## Reply on RC1

This paper summarizes the results of a global unstructured mesh configuration for the WW3 model that uses high resolution to resolve small islands in the tropical ocean. The model spans resolutions between 50km and 100m, and the paper demonstrates its ability to capture the impacts of distant-source swells on tropical island coasts. This global island-resolving configuration is novel and results presented are impressive. Overall, the message of the manuscript is clear and the text is well organized and well written. Below, I have some comments and suggestions that I hope will strengthen and help clarify the paper prior to publication.

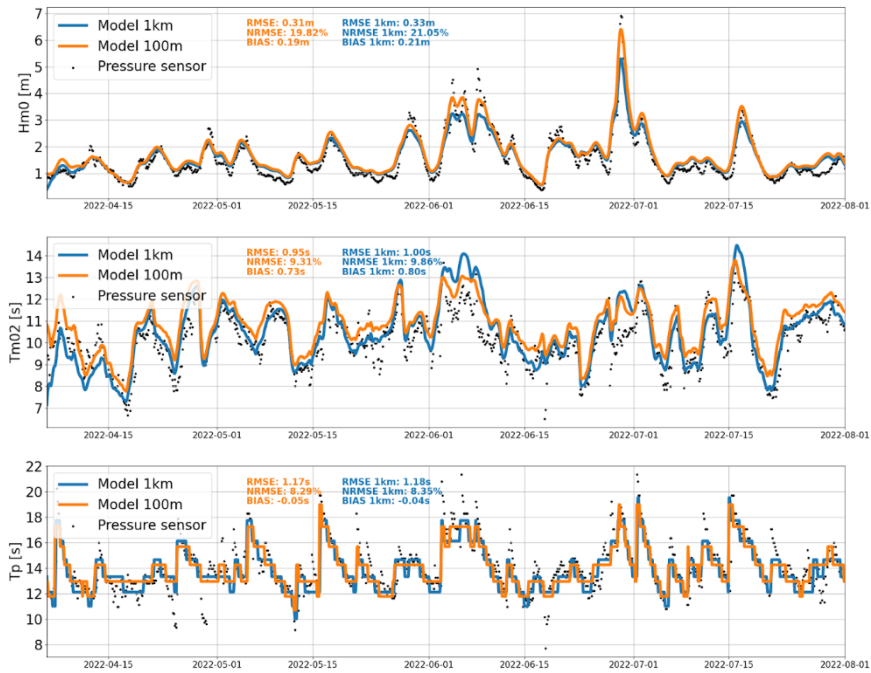
7. The results in Section 3.2 are quite good, but I feel like they could be further strengthened and made more impactful by showing how the wave bulk parameters improve with resolution. For example, it would be really useful to see what 100m resolution buys you in terms of accuracy vs the 1km used for other islands. This would give the reader more guidance on the right level to use for their given application. I understand there may be restrictions here as it relates to resolving the actual observation location. I also understand this would mean developing a new mesh and running more simulations, which may not be practical. However, some commentary on whether 100m there is likely to be a difference between, say 100m and 200m resolution, would be helpful. This is another reason it would be good to be more clear about the local resolution used (see first comment) because that could provide these types of insights as well.

We modified our grid in order to degrade the spatial resolution to 1000 m at La Réunion (see Figure below for the comparison between the two meshes). However, considering the steep bathymetric slopes surrounding the Island, the refinement was too coarse to allow for a consistent water depth in the model and at the location of the pressure sensor so we had to move the output point. Therefore, it is difficult to determine whether the poorer results with the 1000 m resolution are due the poor representation of fast-varying water depths or if they are caused by an interpolation issue. In order to make that point clearer, we added in the revised version of the paper in lines 329 to 332 : *“In order to make clear recommendations concerning the minimum resolution required for such comparisons, we need more adequate measurements and we are waiting for forthcoming high-resolution simulations to carry out comparative studies. Additionally, the issue of resolution remains closely tied to interpolation issues when comparing measurements and model in rapidly varying media.”*

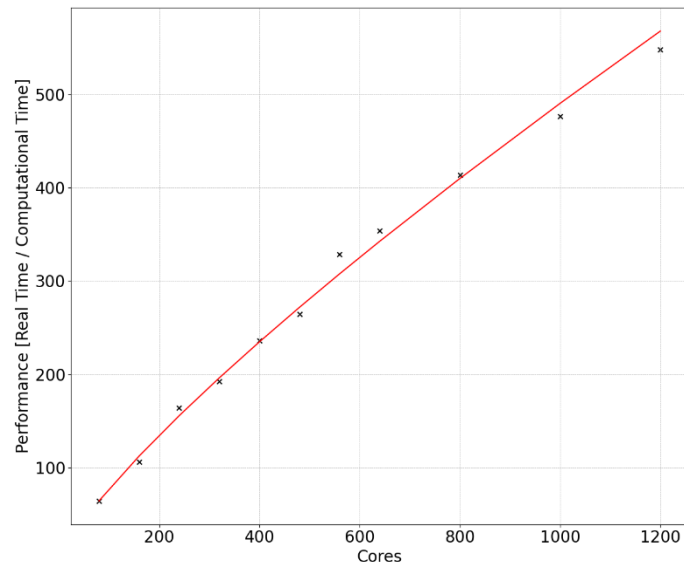
8. More could be said about the computational performance of the model. Line 277 states: “Indeed, for the same computational resources, a one year simulation with implicit scheme took 12 h.” What was the number of MPI ranks used for this to get this throughput and how does the parallel scalability of this configuration compare to Abdolali et al., 2020)?

200 MPI ranks were used in the simulation described, which corresponds to 10 nodes with 20 cores per node. The very good model performance and scalability, as Abodali et et al. 2020 showed in their paper, are shown one figure 2:
